ADDENDUM #2

DRAWINGS

PROJECT TITLE
Georgetown School
Boiler Replacement
Oil Option

DRAWING NUMBER:
181086A SK-6

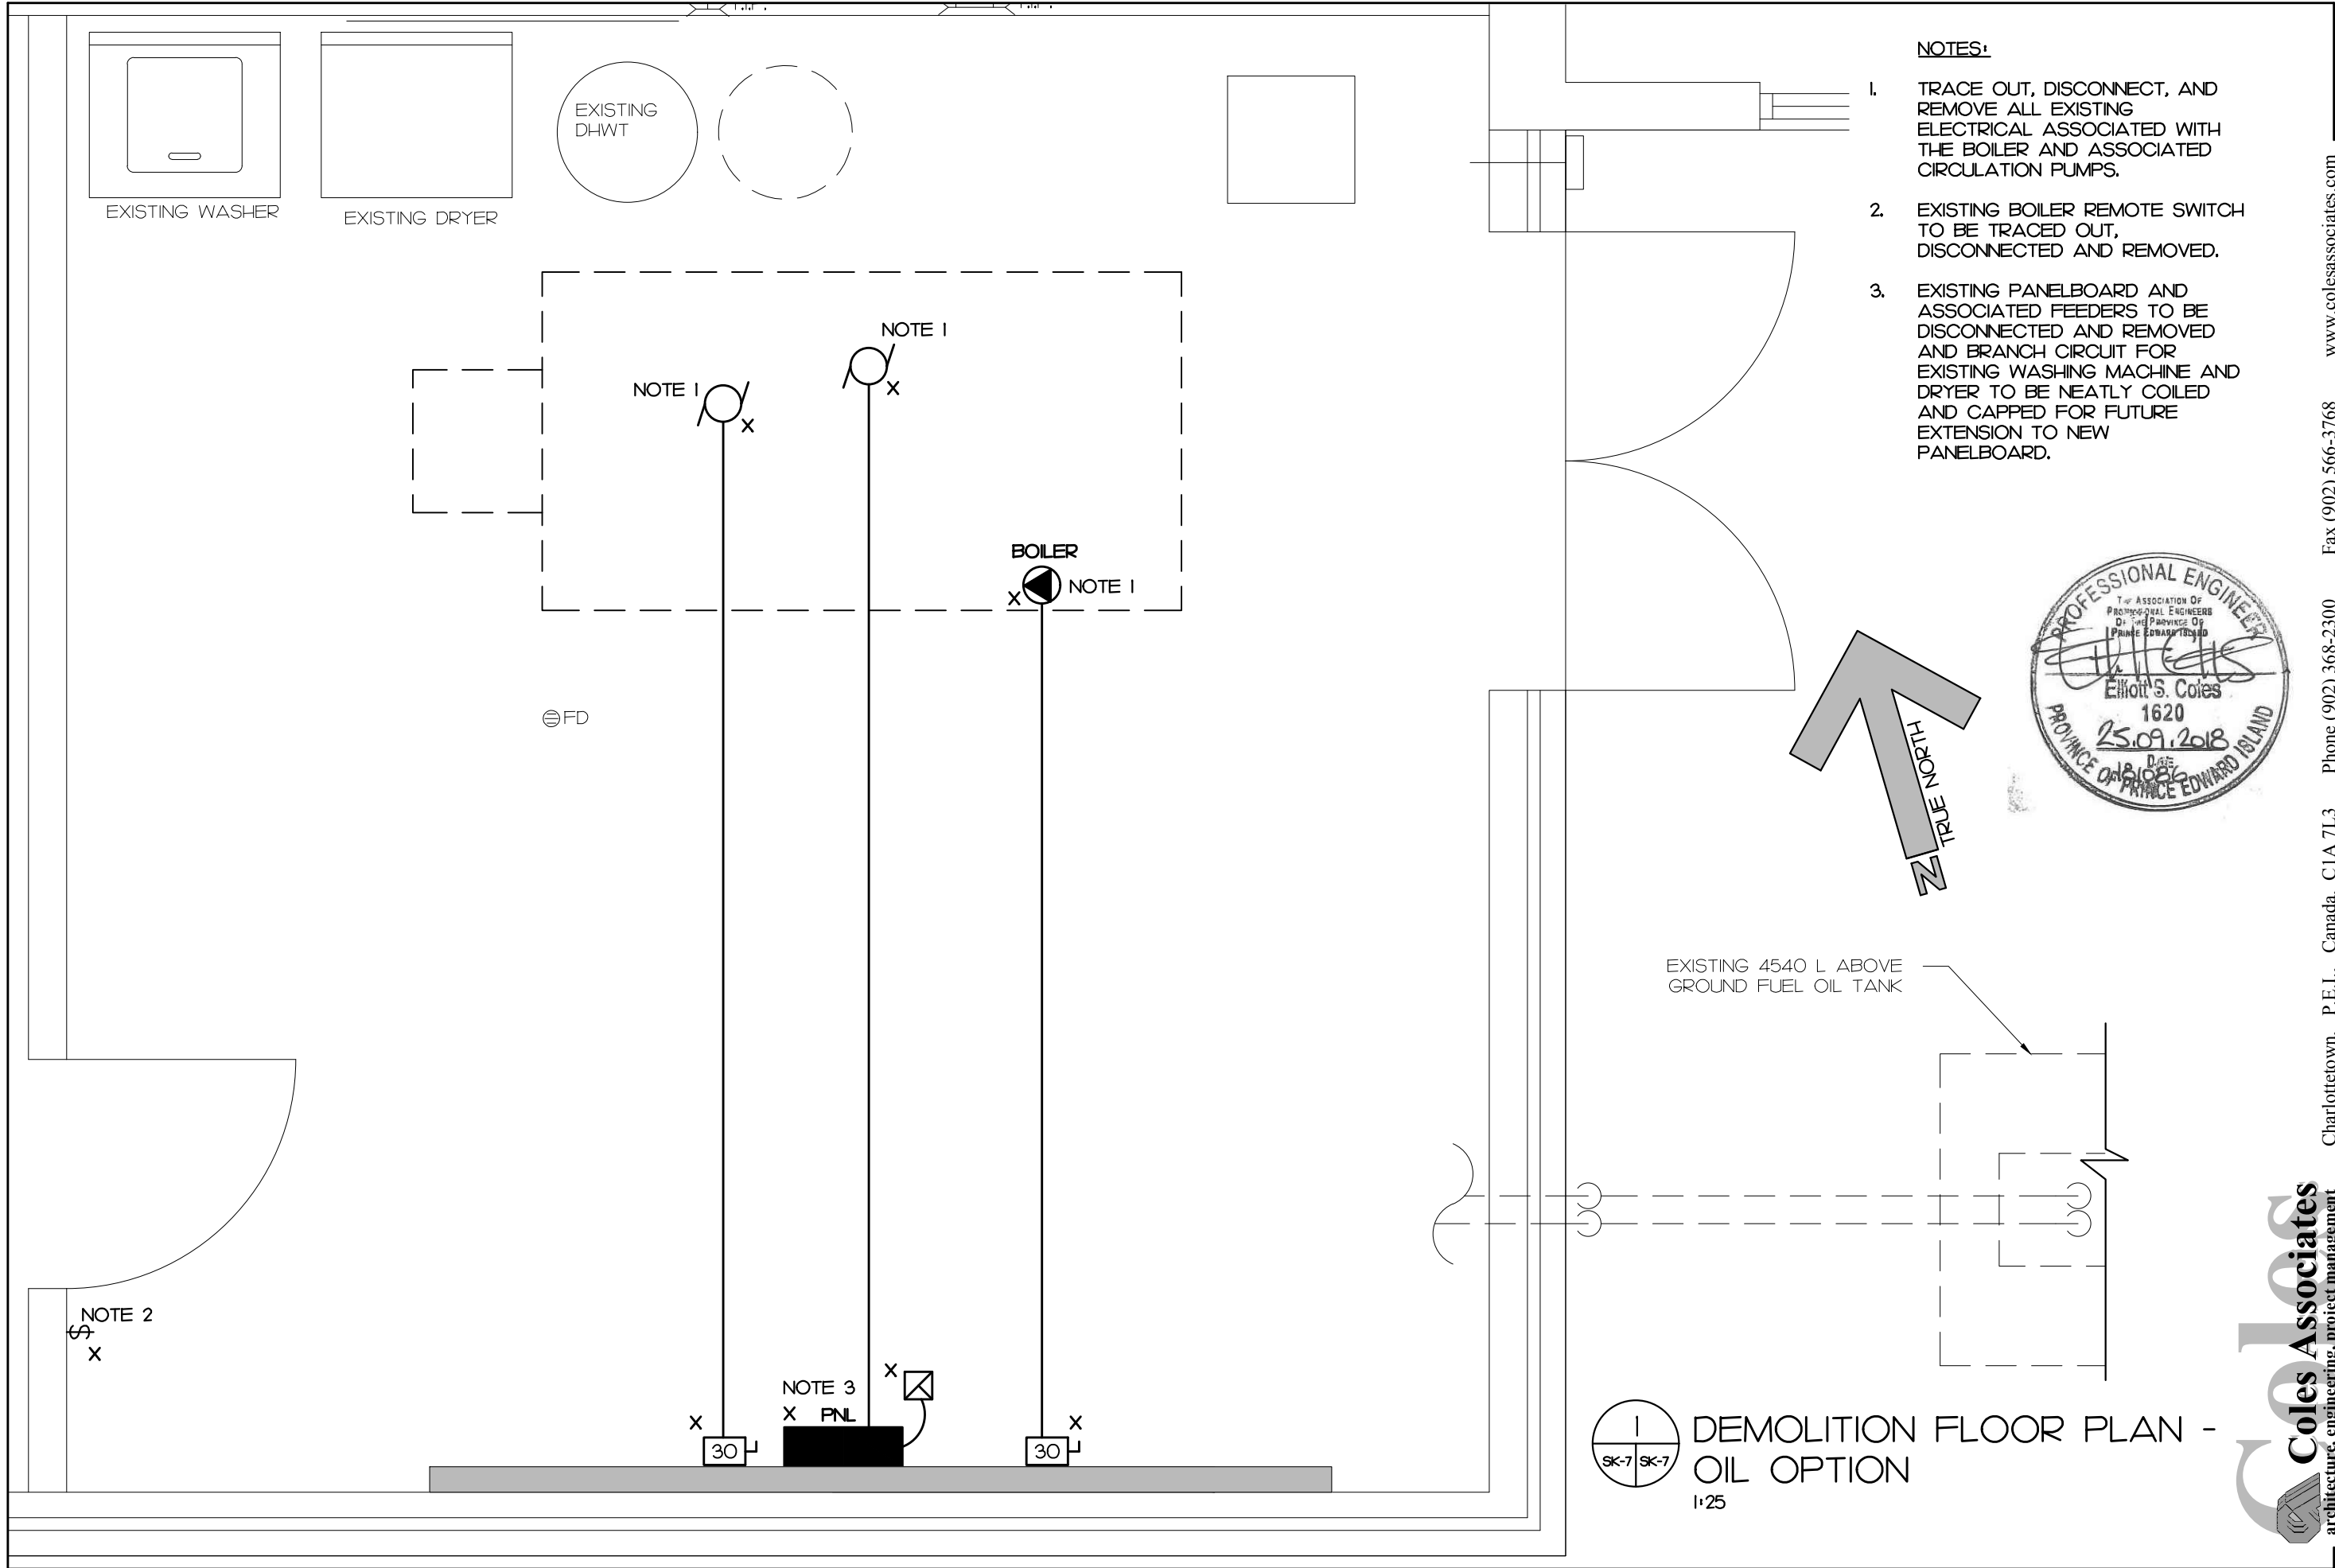
1. Reference Drawing M1 - Demolition & Installation, Mechanical Plans & Schematics:
 - .1 Reference Detail 2:
 - .1 Add following Note:
"Replace existing motorized damper and ductwork with new motorized damper and ductwork. Damper/ductwork dimensions are approximately 24 inches high x 24 inches wide. Contractor to extend ductwork from existing location down to location 24 inches above the finished floor."
2. Reference New Sketches:
 - .1 See sketches SK-6, SK-7, SK-8, SK-9 and SK-10, attached to and forming part of this addendum, for associated electrical work.
